**FORMER BELSIZE PARK FIRE STATION
36 LANCASTER GROVE, LONDON NW3 4PB
LONDON BOROUGH OF CAMDEN**

PLANNING STATEMENT

PROPOSED RESIDENTIAL CONVERSION AND EXTENSION OF
FORMER FIRE STATION (GRADE II* LISTED)

PROJECT: 36 LANCASTER
GROVE
TITLE: SECTION SHOWING
MAIN ROOF
CORNERS
Date: 27th 2015
Scale: 1/200 Sheet: 004
DRAWING NUMBER: 005

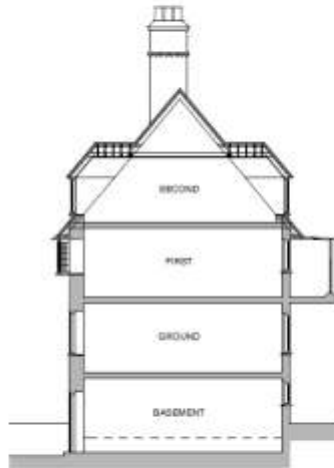
- **Second Floor Units 16-18.** My main concerns with the previous scheme related to the practicalities of using the loft space (particularly Building Regulations) and the imposition of external dormer windows. It is understood that you have received formal advice from your appointed Building Regulations advisors stating that they do not consider it necessary to provide a secondary means of access or escape.
- You have also presented images of your proposed dormers in the context of the southern elevation. In my opinion, these dormer windows do not appear to challenge the architecture of this facade and in my opinion, could be acceptable in heritage terms, providing they are appropriately detailed and constructed (extract of dormer window CGI provided below). (our underlining)

- i. The roof voids within the building, previously serving a storage function, provide generous spaces that simply require natural light to make them useable and attractive living spaces. The architects propose the sensitive addition of dormer windows in keeping with existing dormers on the building and in the surrounding context, so not to detrimentally harm the character and appearance of the building or conservation area context.
